# Catalytic Converter Warranty Extension

### 2006 Chevrolet Malibu L4-2.2L VIN F

### # 10134C: Special Coverage Adjustment - Catalytic Converter Warranty Extension - (Sep 3, 2013)

Subject: 10134C - Special Coverage Adjustment - Catalytic Converter Warranty Extension

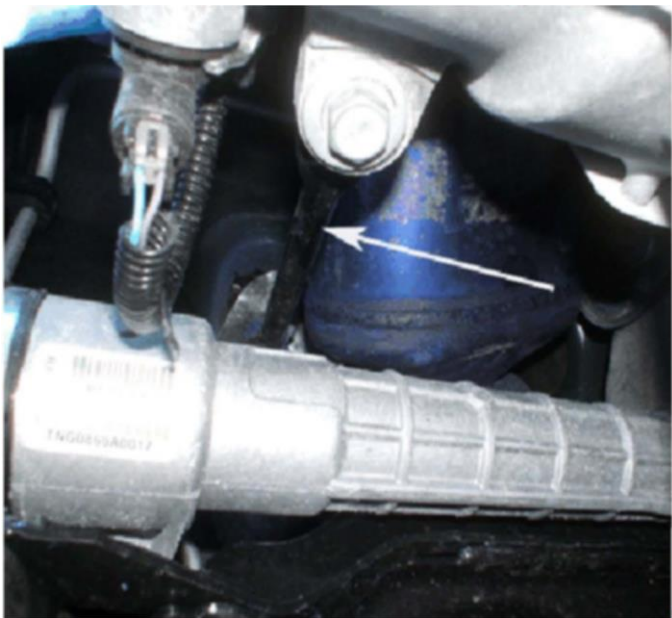
A new catalytic converter bracket (brace) **MUST** be installed on all 2006-2007 model year vehicles, even if the vehicle was not originally equipped with the brace. On 2008-2009 model year vehicles, the original brace must be reinstalled.

When replacing the exhaust manifold/converter on 2006-2007 vehicles only, it is also necessary to install support brace, GM P/N 12617642.

Install the new brace on 2006-2007 model year vehicles, GM P/N 12617642, using a bolt, GM P/N11570734, to attach the brace to the exhaust manifold/converter. Tighten the bolt to 58 [ (43 lb ft).

Use bolt, GM P/N 11518623, to attach other end of brace to the transmission. Tighten the bolt to 53 [ (39 lb ft).
